UNITED STATES PATENT AND TRADEMARK OFFICE

APPLICATION NO.	FILING DATE	FIRST NAMED INVENTOR	ATTORNEY DOCKET NO.	CONFIRMATION NO.
10/813,928	03/31/2004	Admir James Mesalic	MES1.002	5800
39863	7590	09/28/2006	EXAMINER	
SONNABENDLAW 600 PROSPECT AVE BROOKLYN, NY 11215			EDELL, JOSEPH F	
			ART UNIT	PAPER NUMBER
			3636

Office Action Summary

Diagram A - Annotated Figure 6 of Sugawara

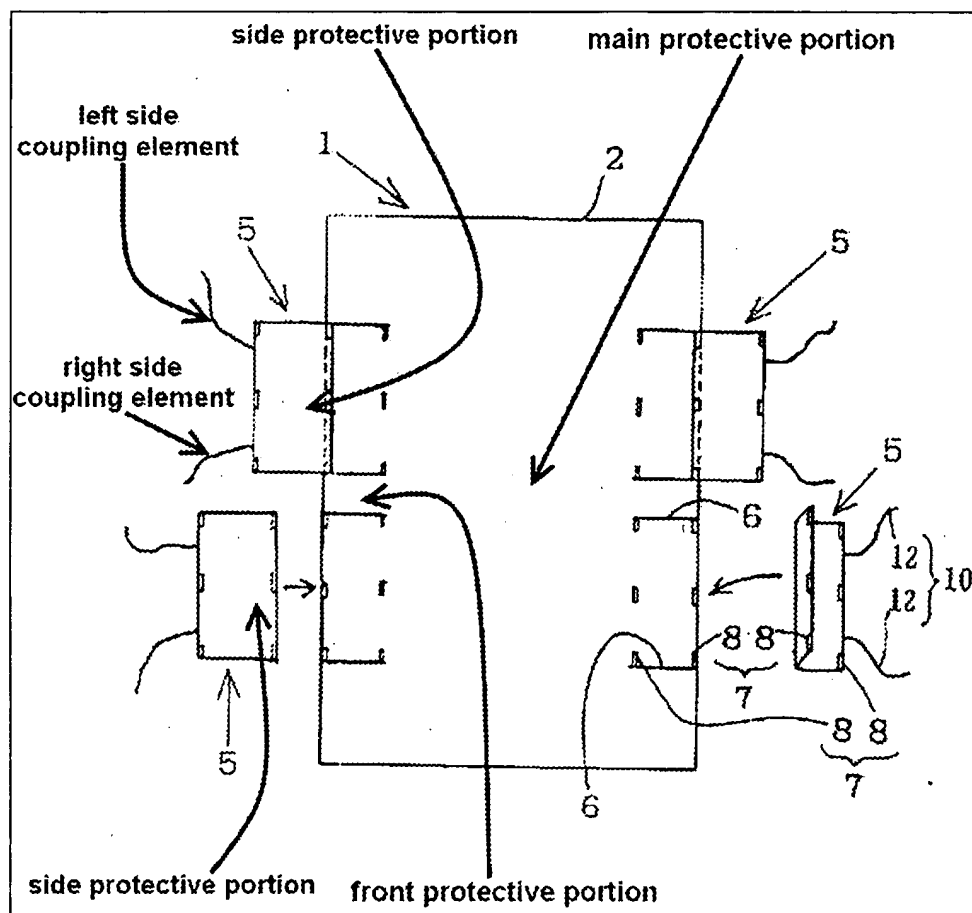
Sugawara discloses a protective covering that includes all the limitations recited in claims 8, 9, 11, 12, 35, 39, and 40. Sugawara shows a protective covering having a main protective portion/main placemat area 2 (see Diagram A below) with top and

bottom surfaces of vinyl (column 3, lines 1-5), a front protective portion/front flap attached to the main protective portion and *capable* of operatively attaching to a front arm portion of a child's chair and of extending from a table top to the child's chair, two side protective portions attached to and extending from the front protective portion, each of the side protective portions having left and right sides, at least one of the side protective portions being *capable* of operatively attaching around one side arm portion of the child's chair by operatively connecting the left side of the at least one side protective portion to the right side of the same side protective portion, each of the protective portions having coupling elements contained on the left and right sides *capable* of operatively connecting the left side of one of the side protective portions to the right side of the same protective portion wherein the coupling elements are ribbon ties, and the side arm portions are orthogonal to the front protective portion. See Figure 10 of Sugawara for the teaching that unused pieces 5 are folded over to attach fasteners 8 thereby creating a pocket of the main protective portion, and, therefore, teaching the limitation recited in claim 11.
